Arboricultural Implications Report
Reserved Matters Application for the
proposed re-development at
Land at and to the rear of 240 Nine Mile Ride
Finchampstead
and
Compliance with Condition no. 13 of Outline
Permission 211889

August 2025

Ref. SJA air 23350-01c

1.2.2. This updated report is intended to address the concerns raised by Wokingham Borough Council in respect to the application to discharge planning condition no. 13 (ref: 251468). The additional detail is set out in Sections 5 and 6 below, and in the access Tree Protection Plan at **Appendix 4**. There are no changes to the arboricultural baseline information (Sections 2 and 3), the trees to be removed (Section 4) or to the relationships between the retained trees and the new dwellings (Section 7).

Figure 2: Showing the previous iteration (left) showing all cypress trees to be removed, and the revised scheme (right) showing the cypress trees along the boundary with Oak Manor retained

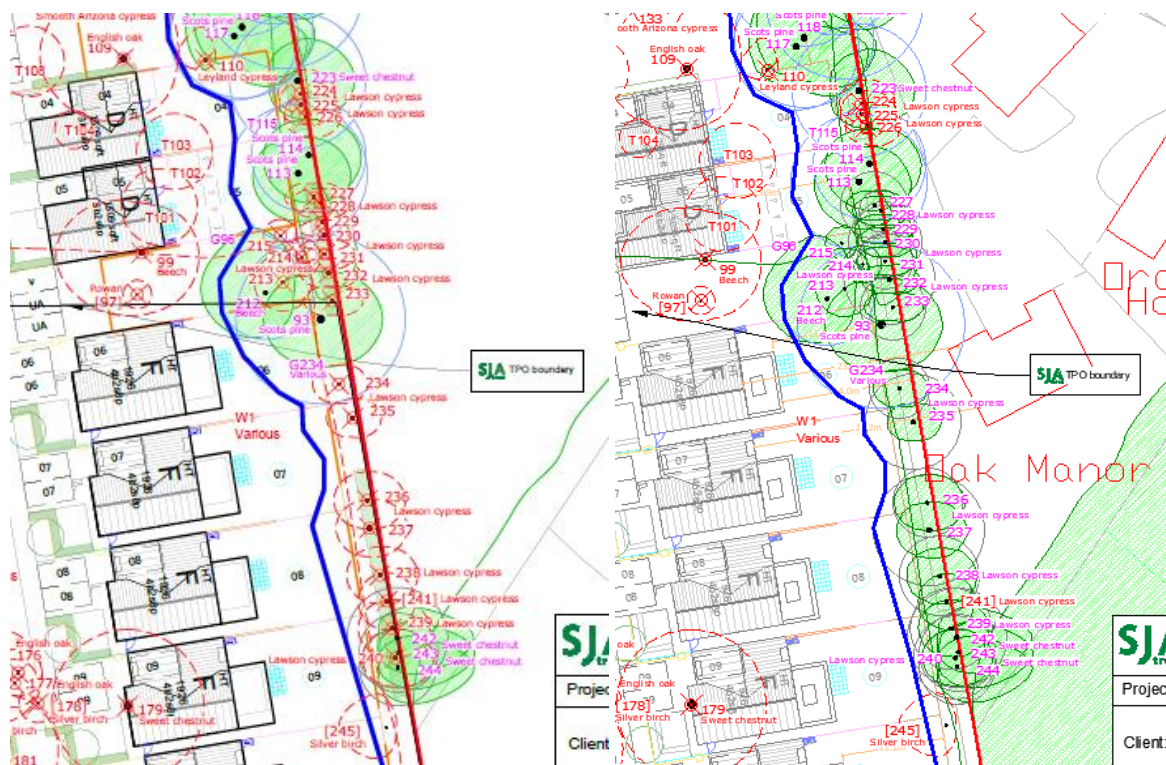
S2. In response to concerns raised by neighbours, the 18 cypress trees (nos. 213-215 and 227-241) growing to the west of Oak Manor and to the east of plots nos. 5 to 9, previously shown to be removed, are now shown retained, as shown in **Appendix 4**.

4.2.2. A comparison between the previously submitted scheme and the revised scheme is shown in **Figure 2** below and in greater resolution at **Appendix 4**.

Figure 3 – Access construction detail

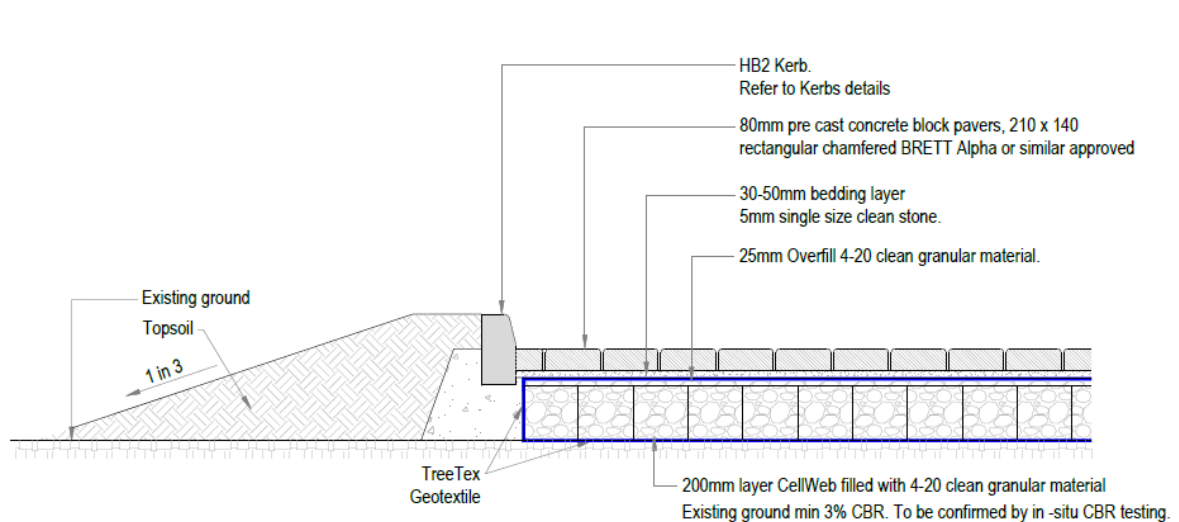
Further to this, it is not clear the approach proposed is suitable for the entirety of the access, as its design should be dependent on the proximity of the tree stems and associated root flare. The detail assumes there is an adequate soil depth/availability that has no constraints. WBC Landscape and Trees would have expected this detail to be included in a final Arboricultural Method Statement with input from the retained Arboriculturist (AC).

- The design of the access road has been amended to ensure the road batters do not conflict with the trunks of the retained trees. This is discussed at Section 6 and the revised engineering drawing set showing the surface levels and construction details will also be submitted for review;

6.2.2. Whilst the detail in **Figure 3** may appear to be standard or arbitrary, they are in fact targeted for the specifics of the expected loads and traffic the road needs to support. They also need to be read in conjunction with the Engineering Layout (ref: 13555-CDY-XX-XX-D-C-0021) and Construction details that provide roughly nine spot heights per 5m chainage based on the existing and proposed level details.

6.2.3. The relationship between the existing levels and the proposed levels is further evidenced in the Craddys long section drawing 13555-CDY-XX-XX-D-C-0030 C01. The RPAs of the retained trees extend from chainage 10.0 to 70.0 (as shown on the Craddys Engineering layout).
